HEDDERMAN ENGINEERING, INC.

REF: CONDITION OF PROPERTY SURVEY - Foundation.

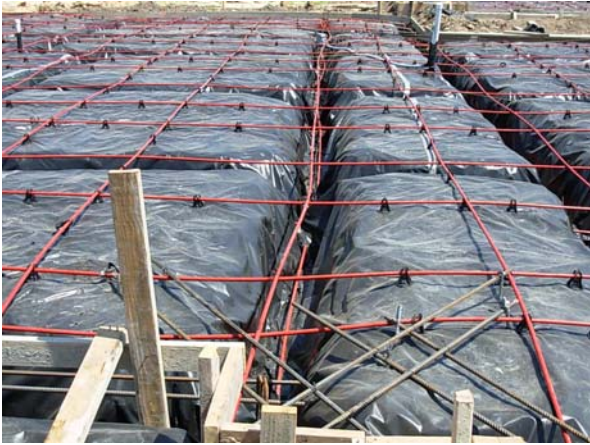
6. The reinforcing steel has been installed in the concrete grade beams and at corners, where bars have been installed at a 45 degree angle to corners. (see photos below)
